Communication on FieldPower® power supply 24V/10A

The IP65 power supply 8000025427 FP BOX SNT10A 2XPT6 is discontinued and replaced by the new IP65 power supplies.

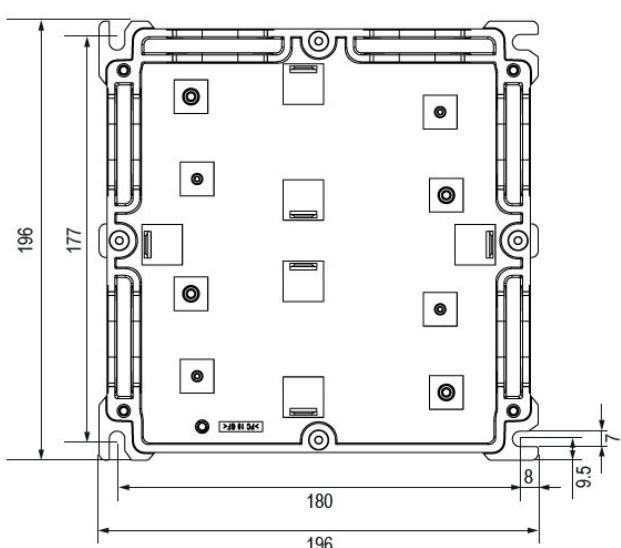
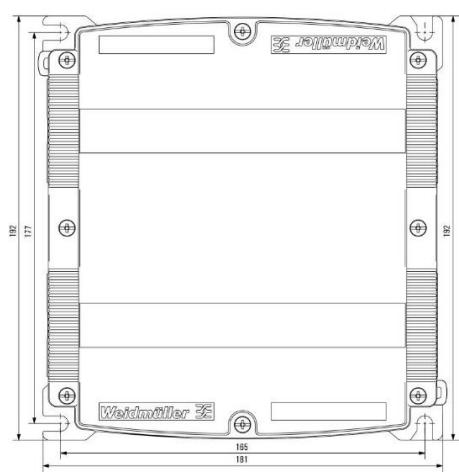
Old version

Power Supply 24V / 10A

Input: 3x 320 ... 575 VAC

Output: 24 VDC / 10 A
150% for 4 Sek.,
100% permanent

No parallel connection

No status relay, no Input

No communication option

W 181 mm, H 196 mm, D 170 mm

New version

Power Supply 24V / 10A and 20 A

Input: 3x 400 ... 500 VAC

Output: 24 VDC / 10 A und 20A
150 % for 5 Sek.,
130% perm. with temperature derating

Parallel connection without diode module

Status relay and input via M12

Communication option available

W 196 mm, H 196 mm, D 220 mm
